SEWAGE DISPOSAL SYSTEM

HOWARD COUNTY HEALTH DEPARTMENT
BUREAU OF ENVIRONMENTAL HEALTH
410-313-2640

TO : Amy McMillen
FROM: Bruce Burton
DATE : December 27, 1999
RE : Brantwood 2/1 F99-140 Lot 5

Re: Brantwood lot 5

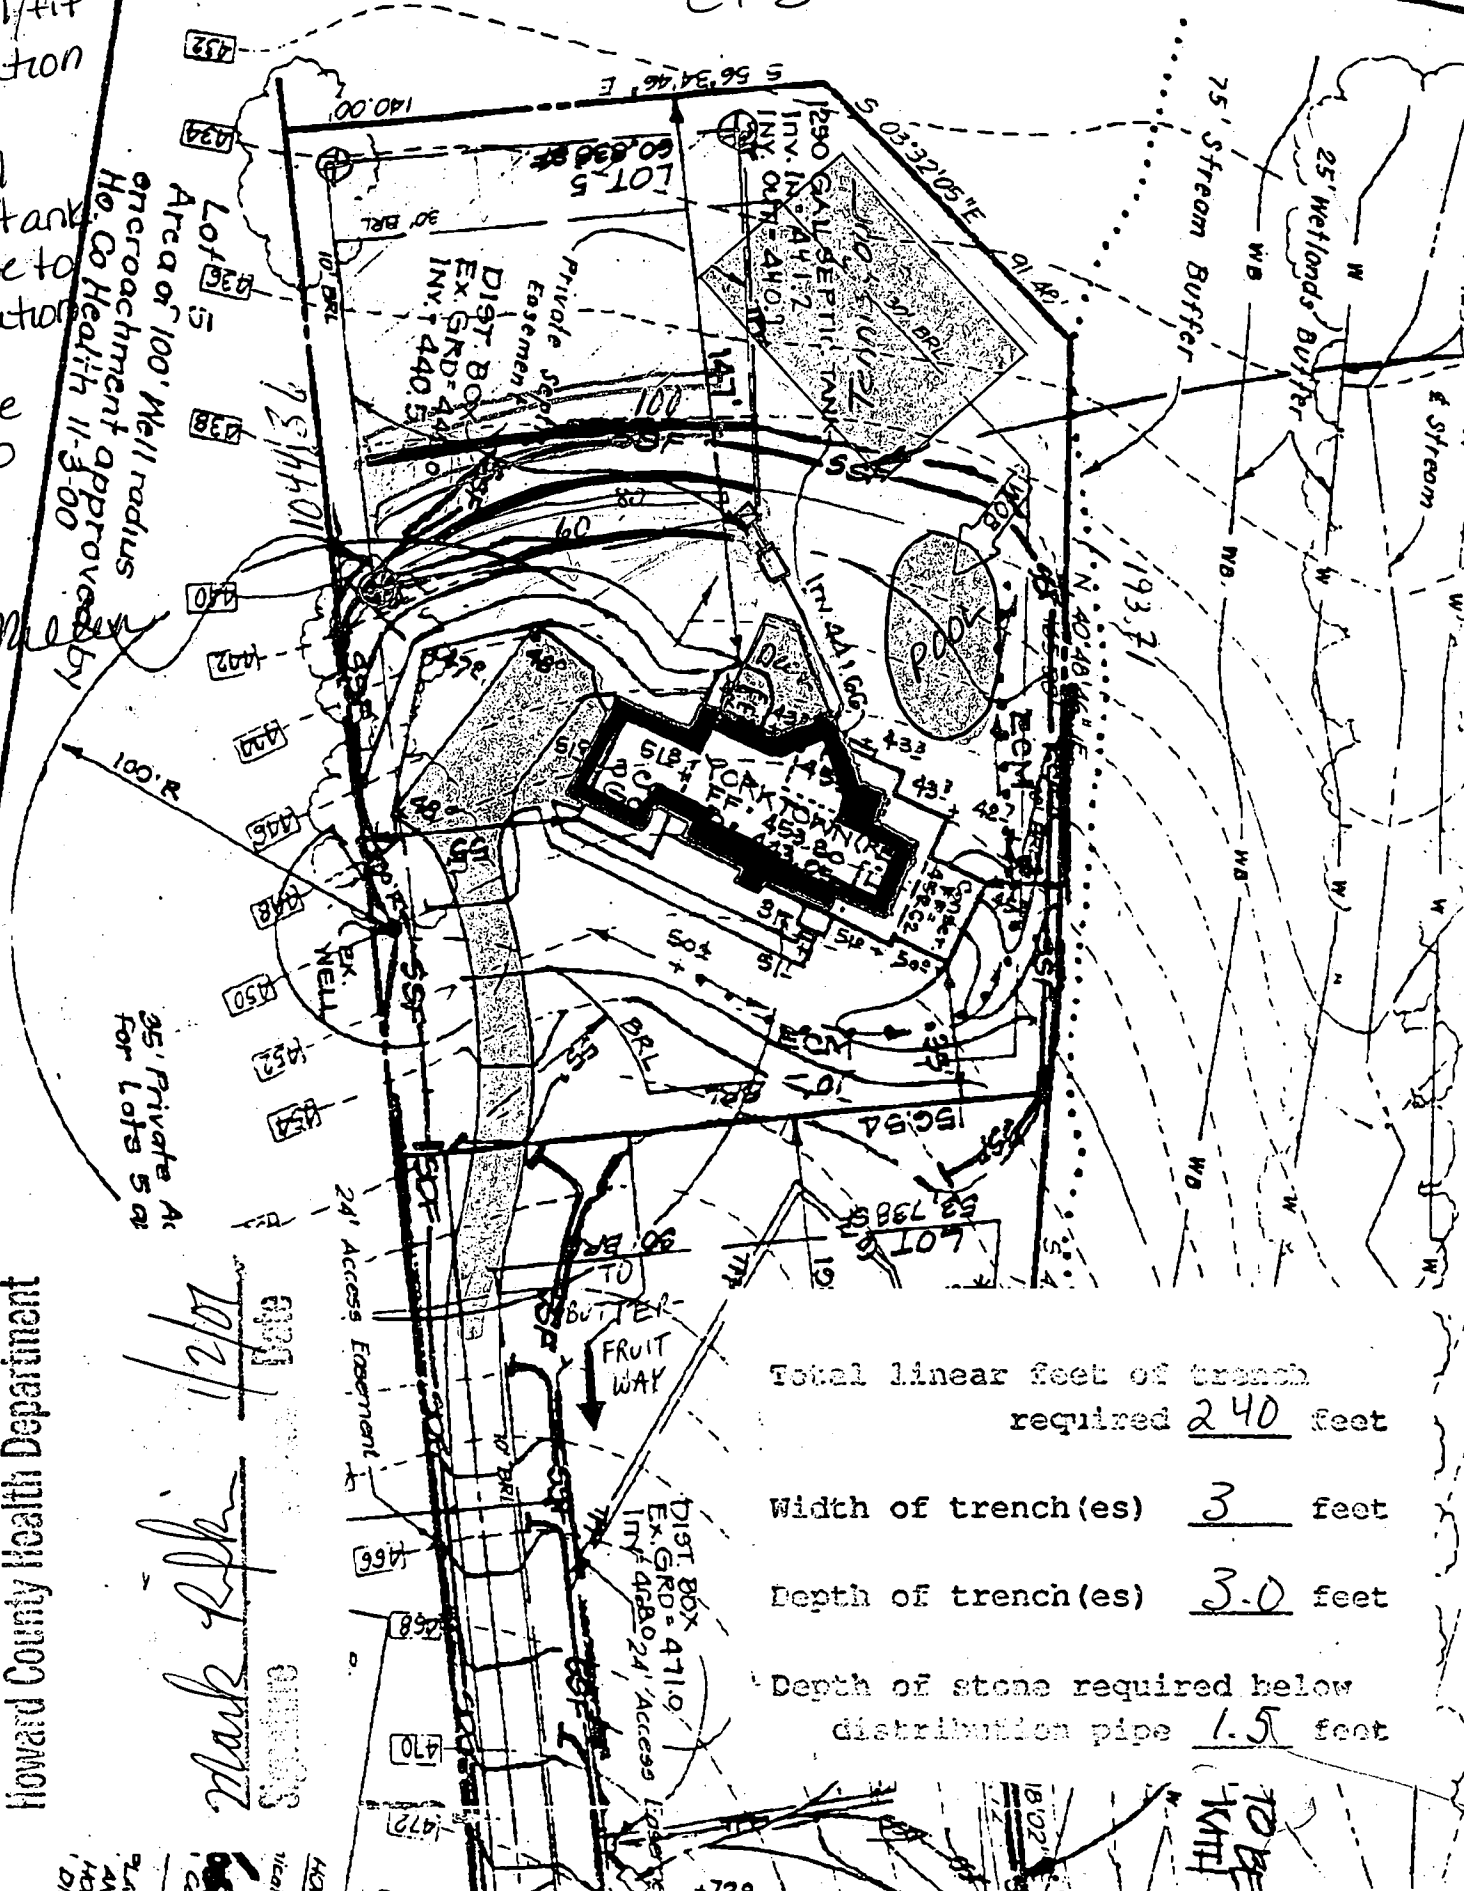
7/11/01
 Tennis court location OK as shown
 Pool will fit in location shown
 Install septic tank as close to distribution box as possible due to shown deck
 Area of 100' Well radius
 Ho Co Health 11-3-00
 Approved by

ALTERNATE #1

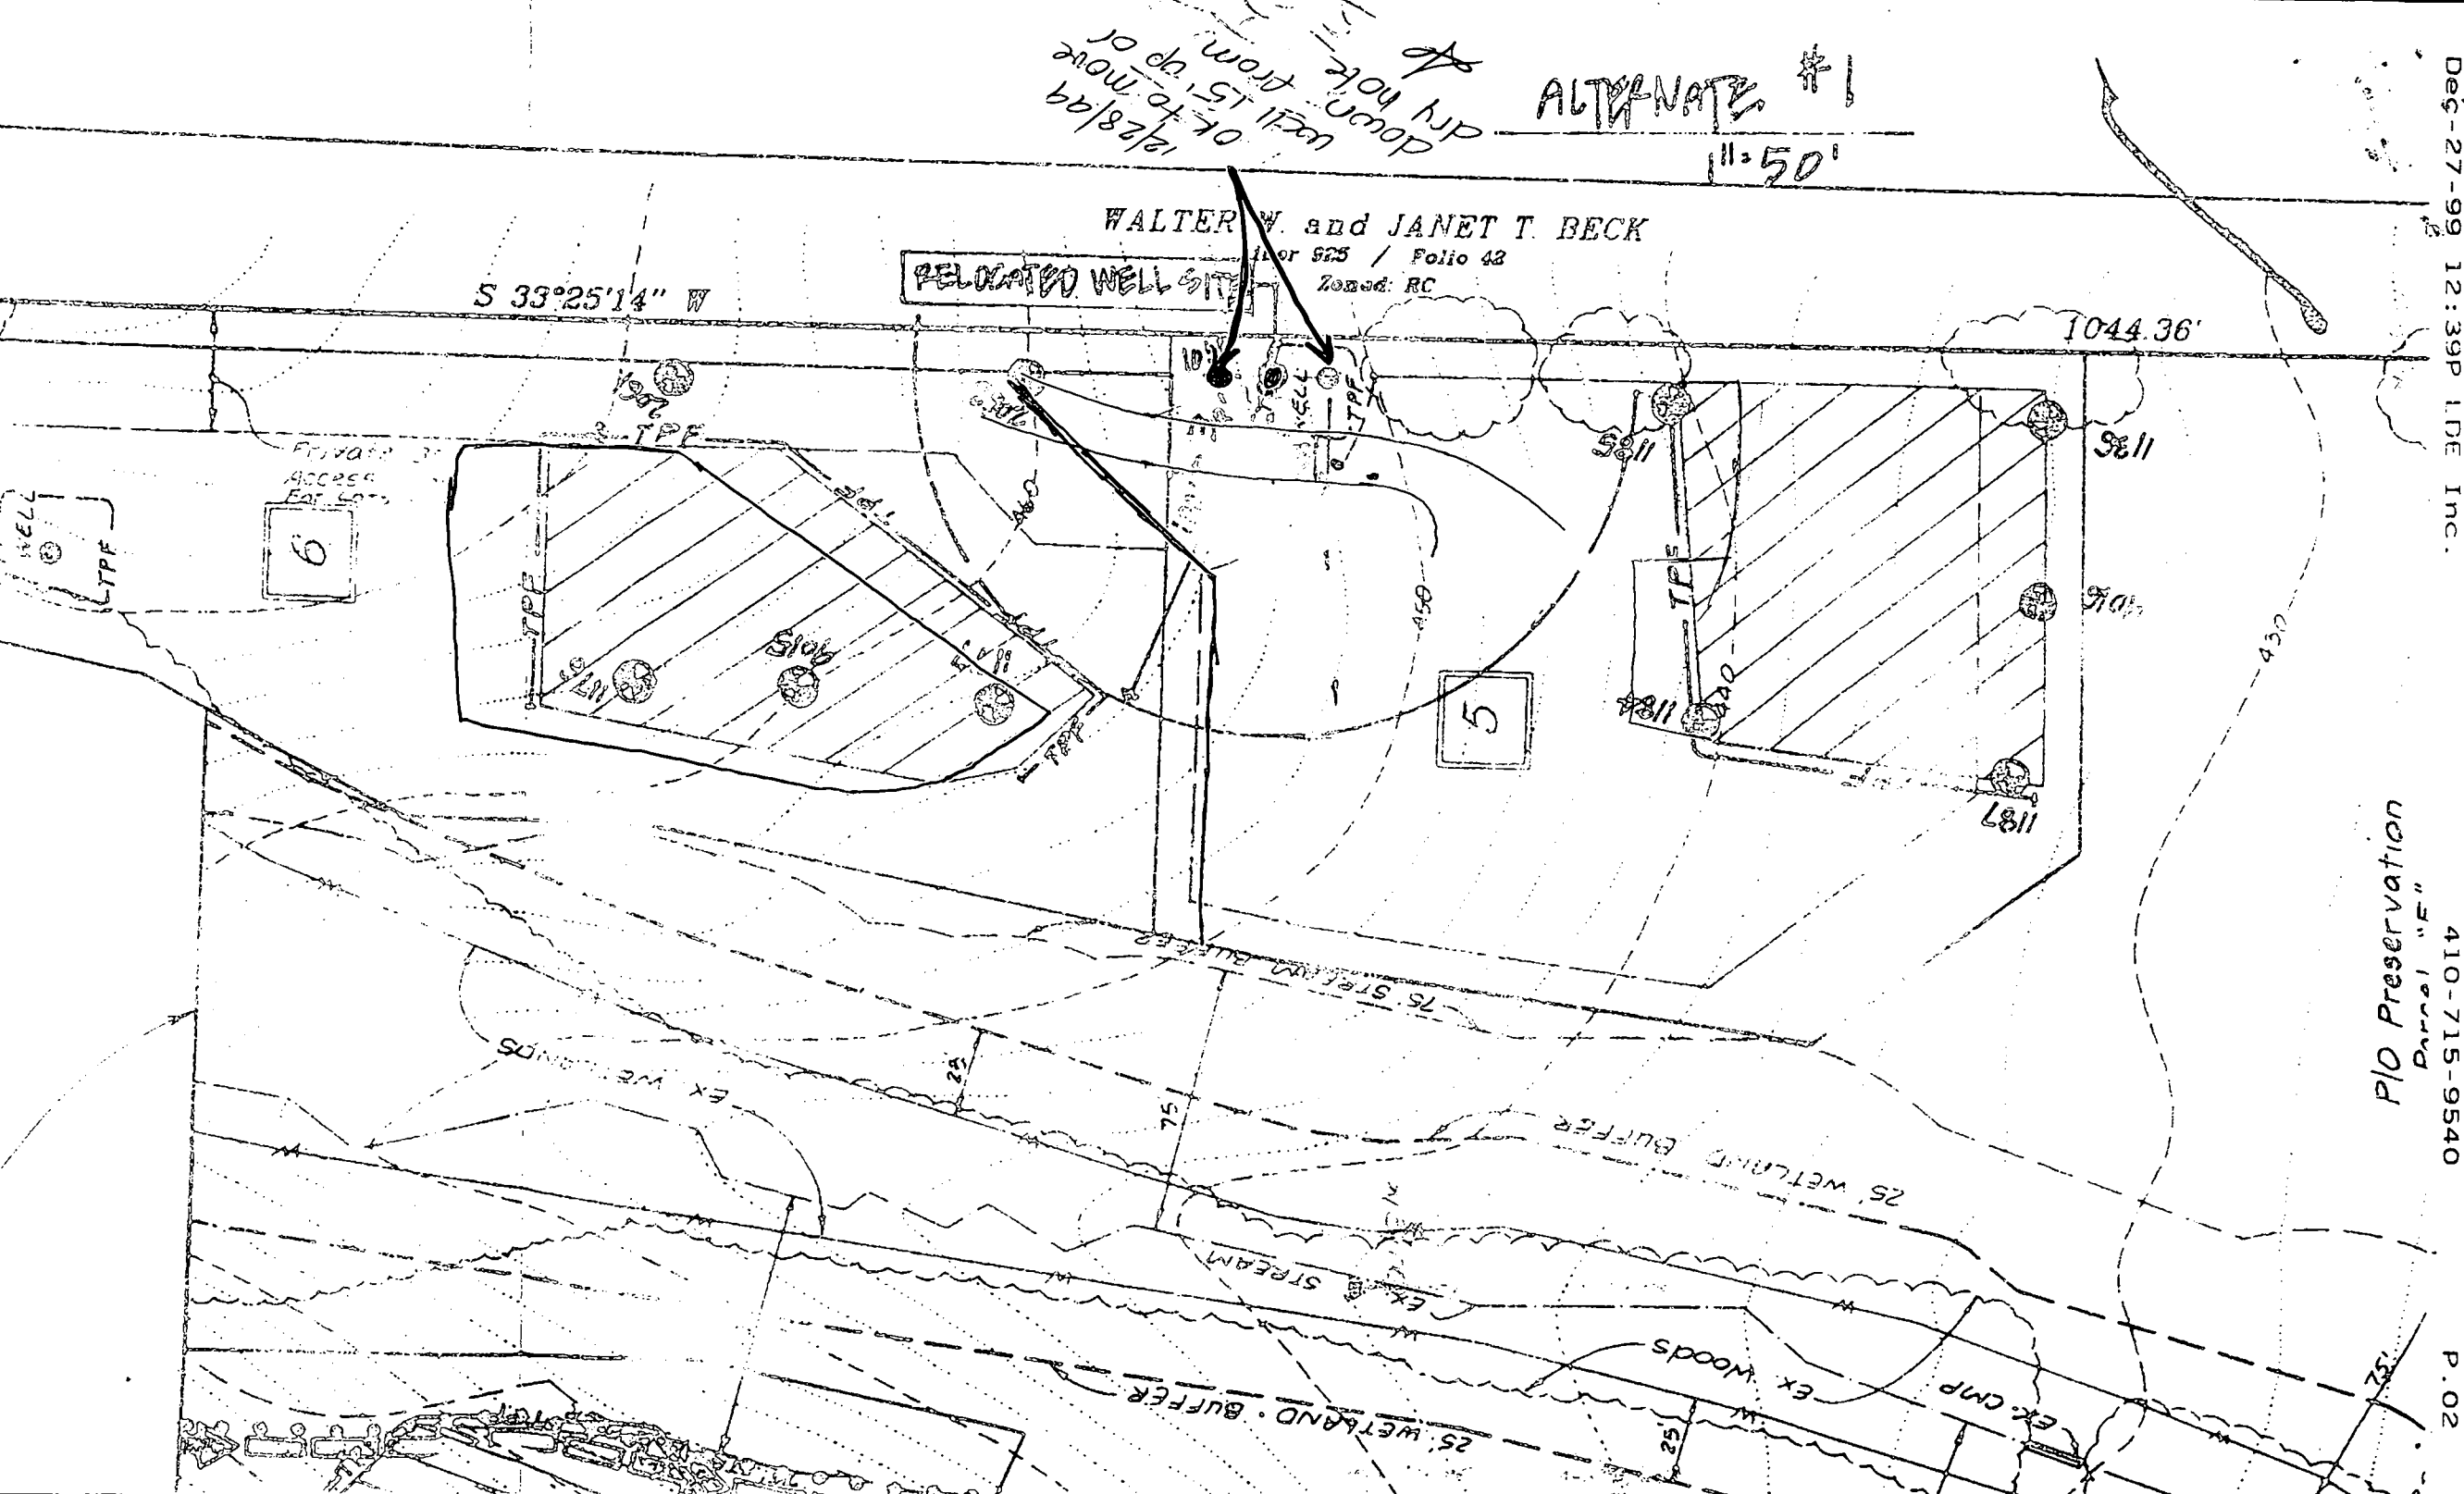
12/28/99
OK to move
down 15' up or
dry hole from top

ALTERNATE #1

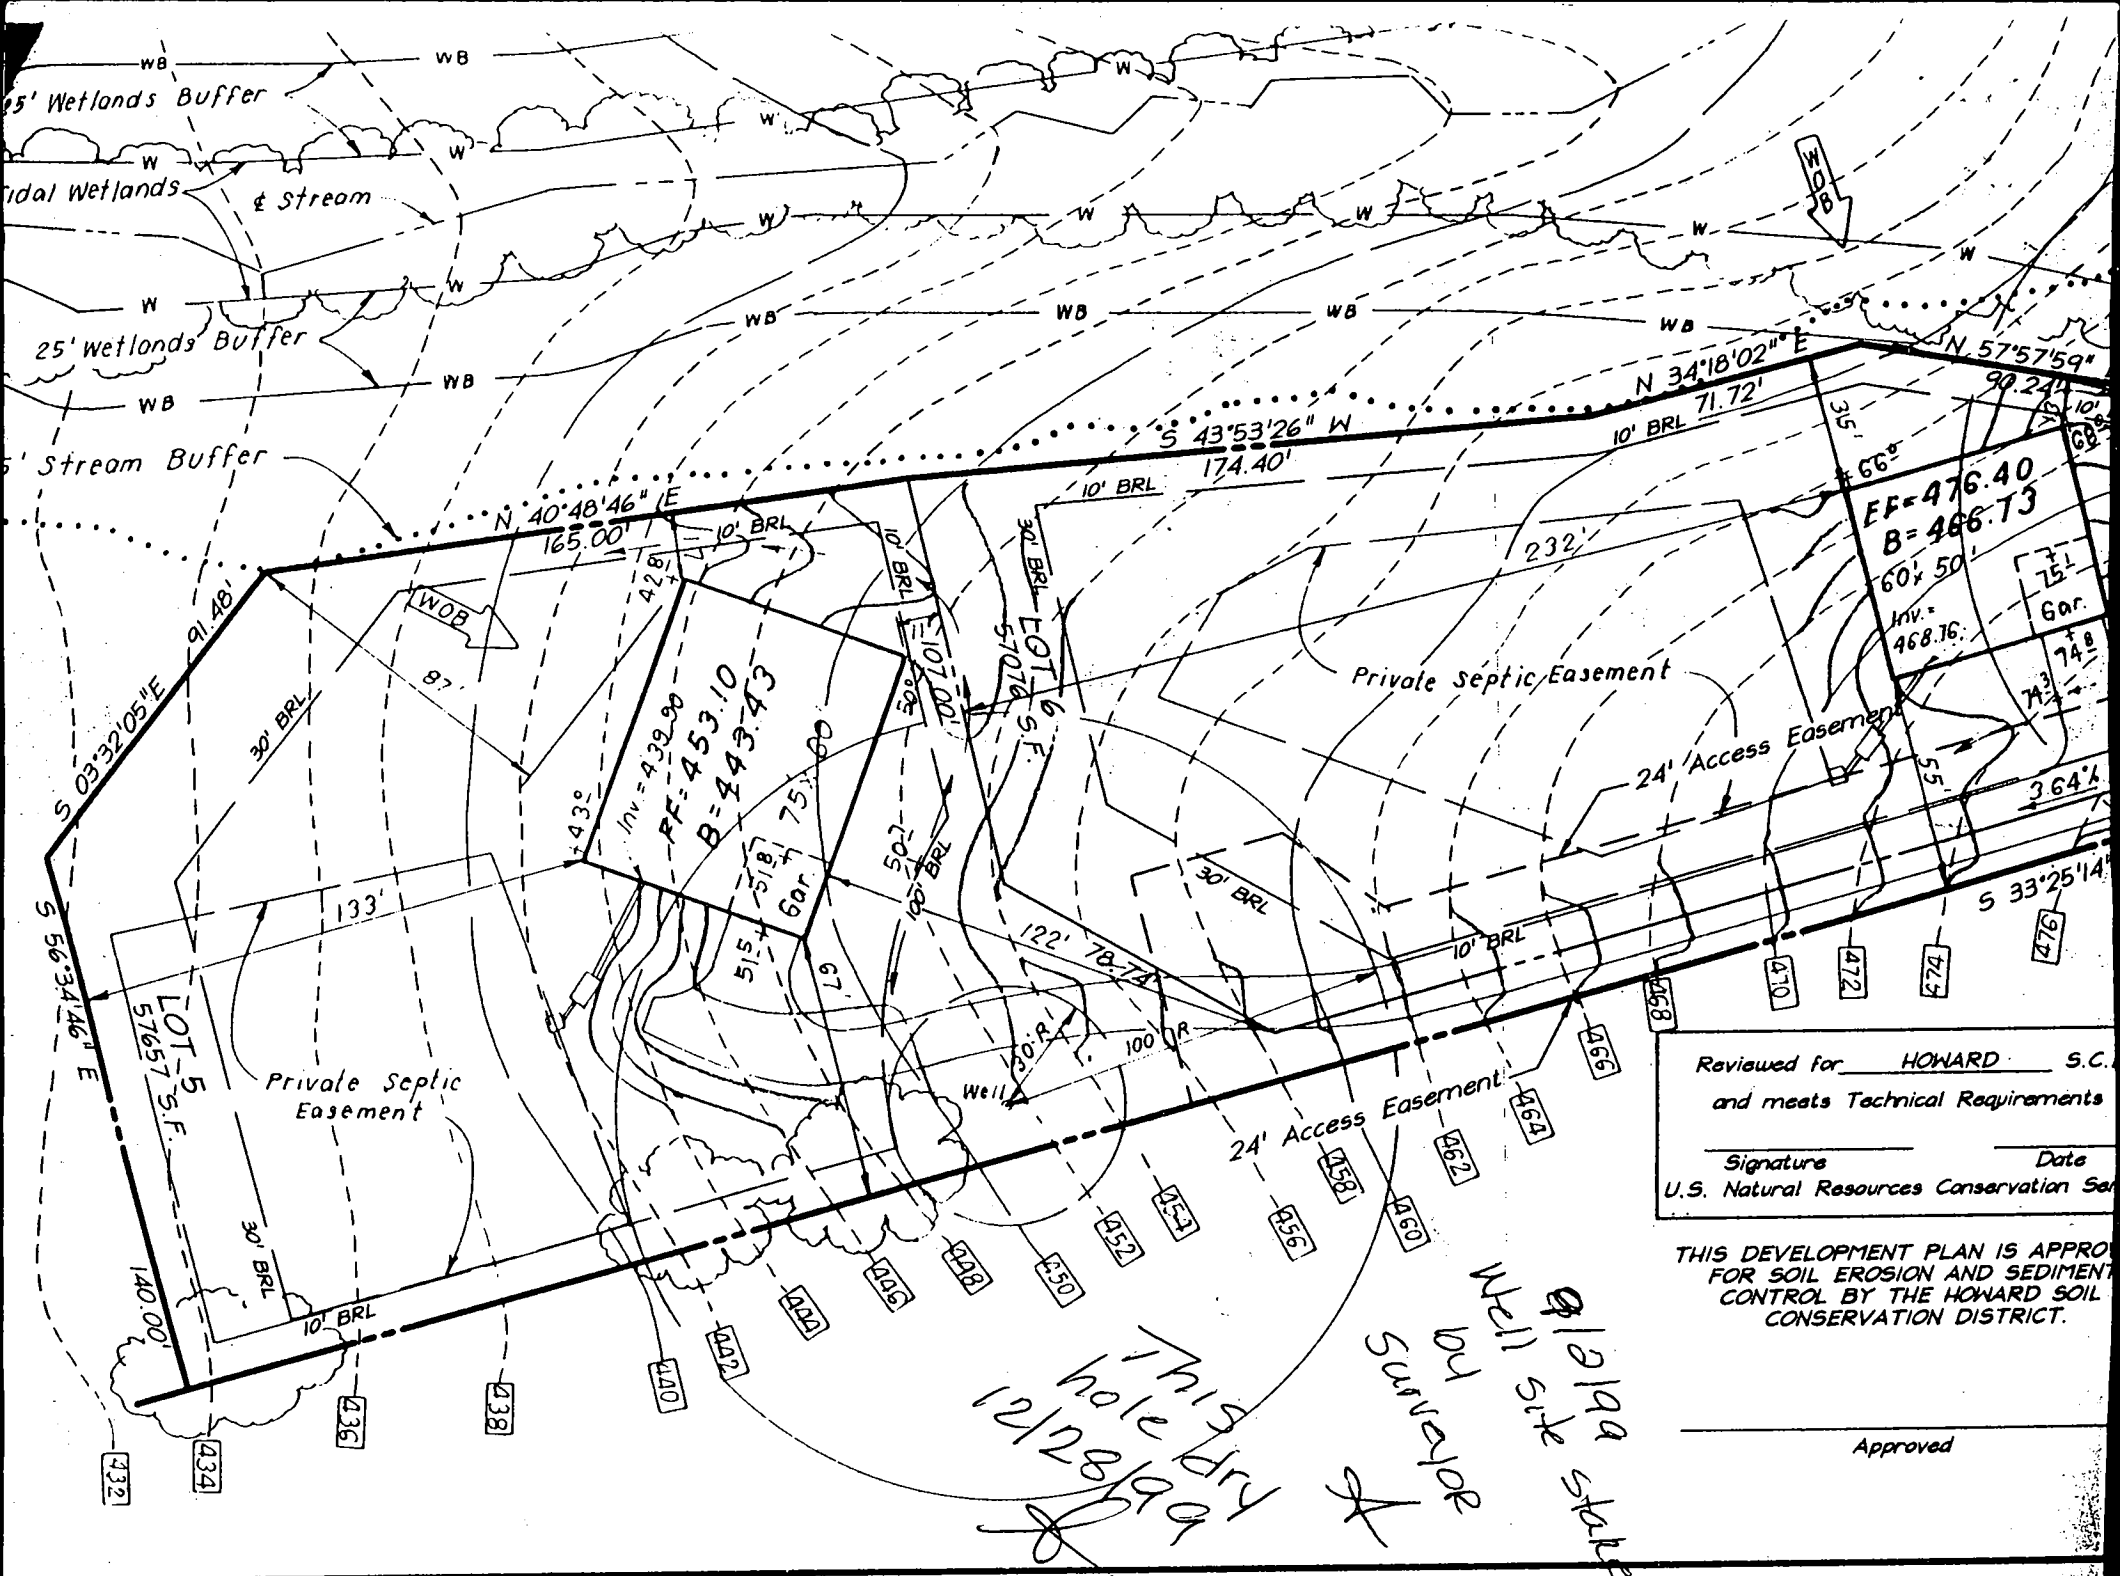
This hole dry
 12/28/99
 Well site stamped
 on 1/9/99

12/28/99 This site not approved due to proposed driveway
